**Subject** ▶ Change on shear blade assembly

**For Models** ▶ UM1000D/DW and UM1070D/DW (Cordless Grass Shear)

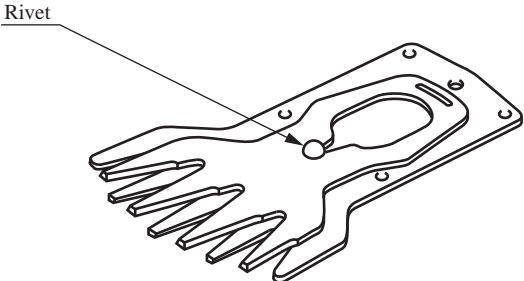
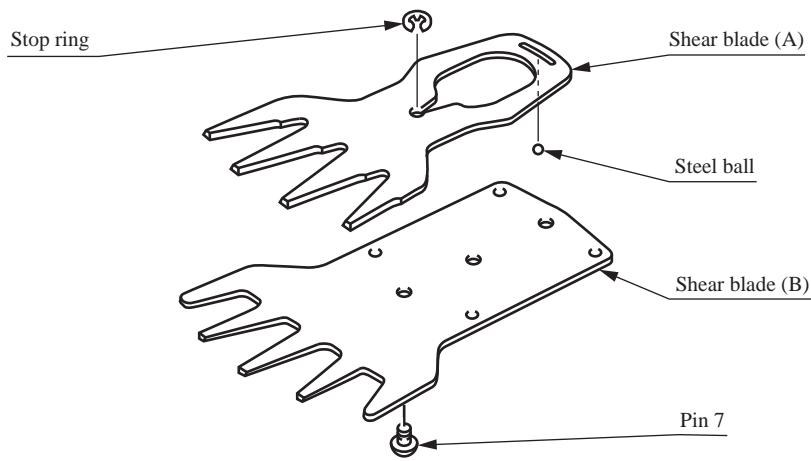
**Description** ▶ The method of assembling the shear blades (A) and (B) will be cchanged as follows.

<p>► <b>Current</b></p> <p>The shear blades (A) and (B) are assembled with the rivet caulked.</p>	
<p>► <b>New</b></p> <p>The shear blades (A) and (B) will be assembled with a stop ring and a pin. The shear blade assembly can be disassembled for easier sharpening of it.</p>

Item No.	Current part		Q'ty	I/C	New part		Q'ty	Note
5	Shear blade assembly 122292-2		1	Yes	Shear blade assembly 125030-1		1
